SUBJECT: CORRECTION TO AMENDMENT NO. 57 TO FACILITY OPERATING LICENSE NO.  
NPF-29 - GRAND GULF NUCLEAR STATION, UNIT 1 (TAC NO. 71438)

Amendment No. 57 to License No. NPF-29 was issued on March 13, 1989 with an incorrect page, 3/4 2-6, in Appendix "A" Technical Specifications (TS).

FIGURE 3.2.3-2 MCPR<sub>p</sub>

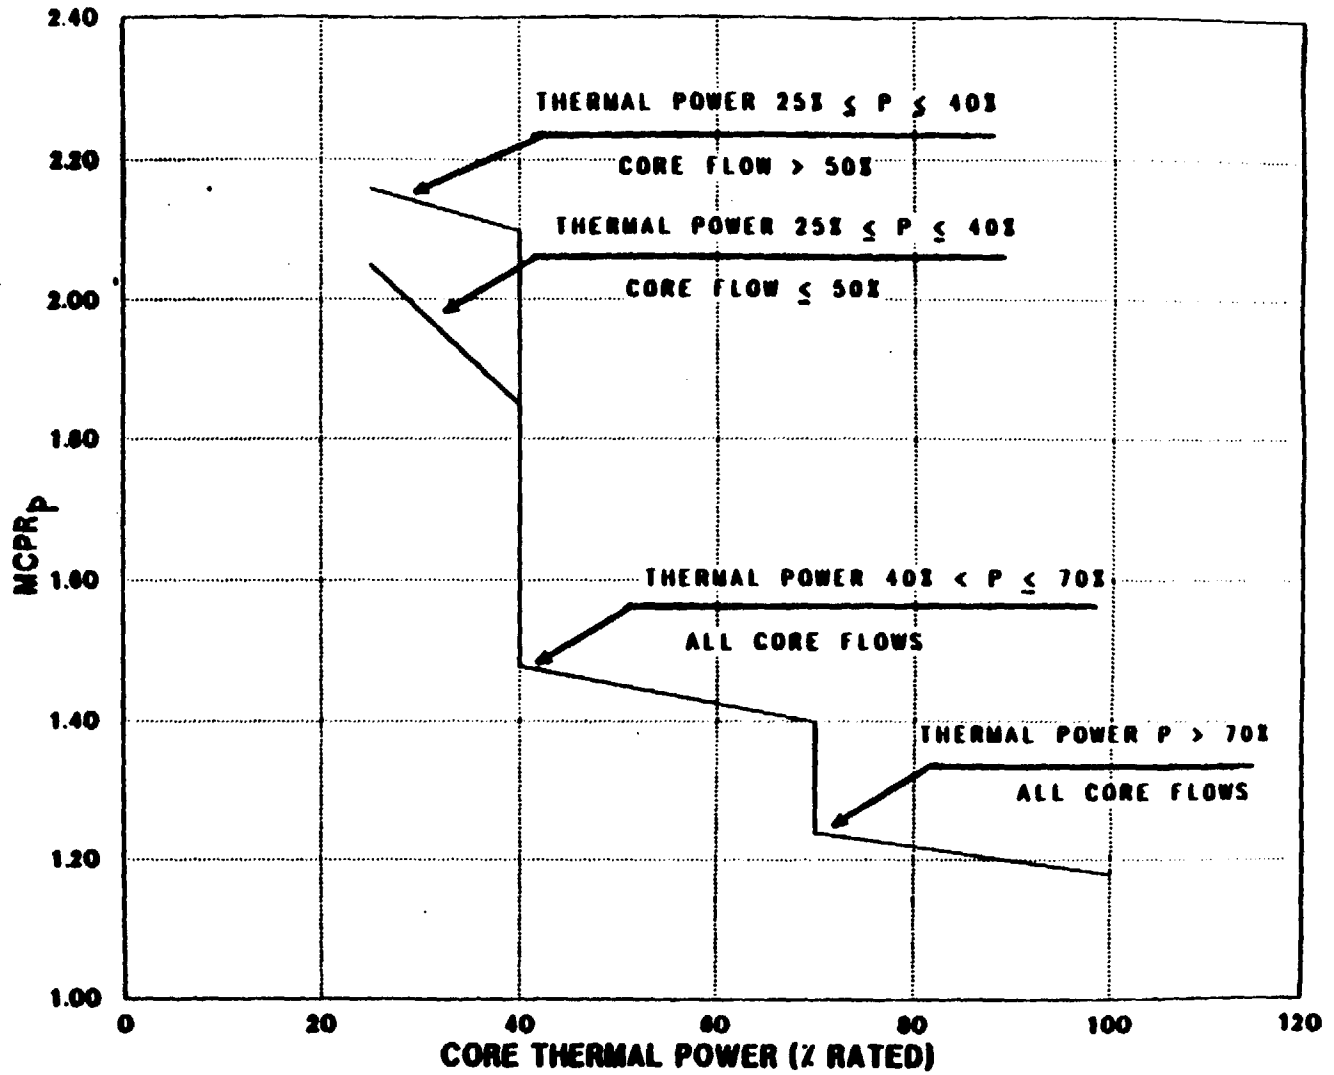
Please replace page 3/4 2-6 in Amendment No. 57 with the enclosed corrected page.
